**From:** David Lochbaum <davelochbaum@gmail.com>  
**Sent:** Monday, August 17, 2020 8:23 PM  
**To:** Paul  
**Cc:** Linda Seeley; Brian Haagensen; Skeen, David; Raspa, Rossana; Jarriel, Lisamarie; Spicher, Terri; Doane, Margaret  
**Subject:** [External\_Sender] Re: DCL-20-066.pdf

Piping downstream of the LCVs between the AFW pumps and the steam generators on Unit 2 was discovered to have worn to less than the allowable wall thickness, requiring its replacement last month. PG&E assumes, with reason, that the piping on Unit 1 is in a similar condition.

Here's a schematic of the AFW system at Diablo Canyon:

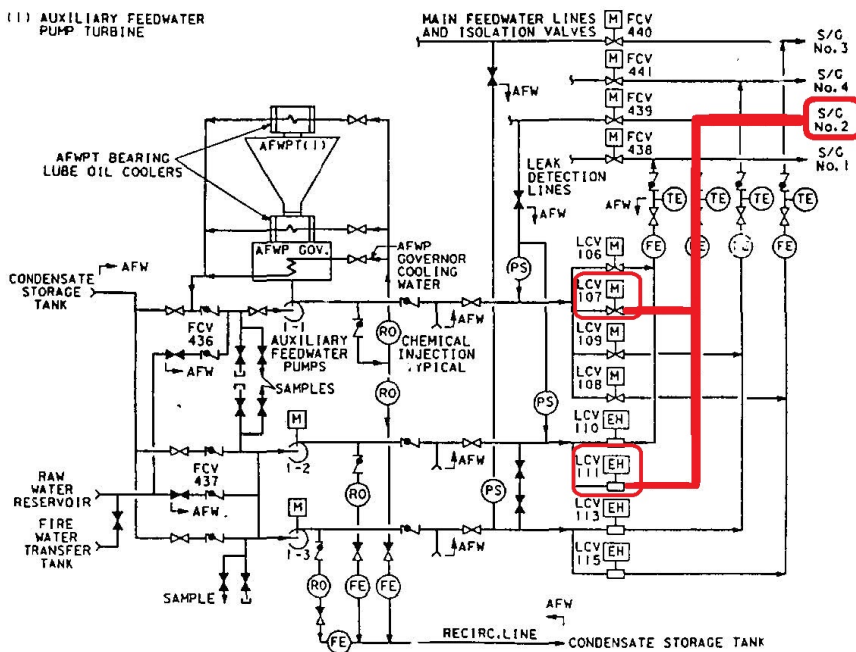
The red lines show the piping downstream of LCVs 107 and 111 that supply flow to Unit 1 Steam Generator No. 2.

The AFW system features three pumps (one turbine-driven and two motor-driven). The turbine-driven pump provides 200% of the flow required to remove decay heat post shutdown. Each motor-driven pump provides 100% of that flow. So, one pump and one flow path to any one of the four steam generators is needed to fulfill the safety function.

The requested amendment will allow PG&E to isolate the flow path to one steam generator for up to seven days. Worst case, there would be the need to individually isolate and replace piping sections in all four pathways (one at a time) for a total outage time of up to 28 days.

When each individual flow path is isolated (i.e., LCVs 107 and 111 closed or comparable valves on the other paths), all three AFW pumps and three other flow paths would remain available.

Suppose LCVs 106 and 110 are closed to replace the piping to steam generator 1-1. If the normal feedwater system is lost, the AFW system will auto-start. The full flow from all three AFW pumps would be routed to three rather than four steam generators. Given that the requested amendment is predicated on expected piping less than the allowable wall thickness, the greater-than-normal flows through the three lines at higher than normal pressure could lead to the common cause rupture of all three flow paths to the non-isolated steam generators. Thus, a complete loss of AFW concurrent with loss of the normal feedwater system.
